January 7, 2022

RE: Official Public Comment on the MoPac South Environmental Study Virtual Public Meeting Number Five

Compliance with CAMPO 2045 Plan

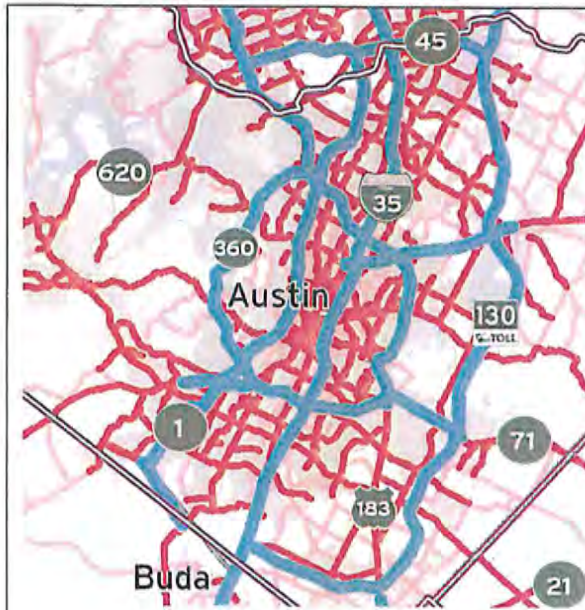
<p>(a) Loop 1 is classified, from 45N to the 45SW, as a “limited access” segment, a “principal arterial” segment, a “limited access” segment, a “principal arterial” segment, a “limited access” segment and a “principal arterial” segment. The Regional Corridor Inventory previously provided to the City of Rollingwood does not reflect a separate description for each of these alleged segments, and also does not include any project description for Loop 1 South of Cesar Chavez.</p> <p>(b) In addition, it is unclear from the Arterial Boards what criteria is used to label a segment of a roadway as “limited access” or “principal arterial”. There are portions of Loop 1 illustrated that include “managed lanes” and are labeled as both a “principal arterial” and “limited access” and there are portions of Loop 1 illustrated that do not include managed lanes and are labeled as both a “principal arterial” and “limited access”.</p> <p>(c) Bee Caves Road is shown as a “principal arterial” from east to west, however, the Regional Corridor Inventory describes 9 segments of Bee Caves Road.</p> <p>(d) It is unclear whether the Regional Corridor Inventory previously provided to the City of Rollingwood was informed by the “existing” map on page 7 of the “Arterial Boards” or whether the Regional Corridor Inventory has been updated to reflect the “existing” map.</p>

(4) As to the “Scenario B” map on p. 9 of the “Arterials Boards”:

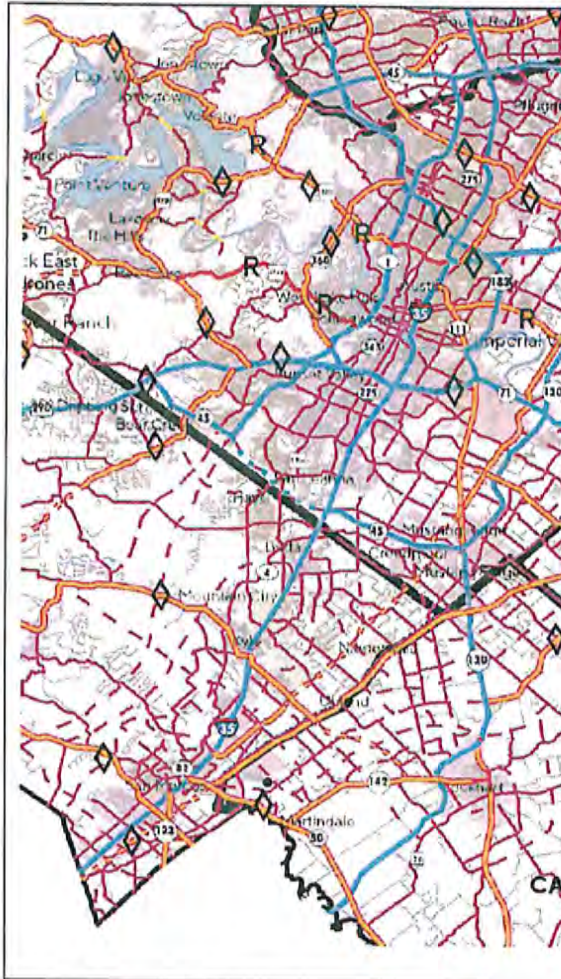
(a) "Scenario B" does not show the now opened SH45SW, but instead proposes upgrading an additional potential through-traffic bypass from I-35 onto Loop 1 through Buda and Brodie Lane. The Regional Corridor Inventory provided to the City of Rollingwood only includes descriptions of projects in Travis County and the proposed "Scenario B" does not provide sufficient information for evaluating the impact of the proposed regional corridors in Hays County to connect to Loop 1. Again, the City of Rollingwood is opposed to converting Loop 1 into an I-35 bypass, to the detriment of local, daily traffic, which would be effected if Loop 1 is designed with multiple regional corridors directly connecting from I-35 South of downtown Austin, through Loop 1, to I-35 North of downtown Austin.
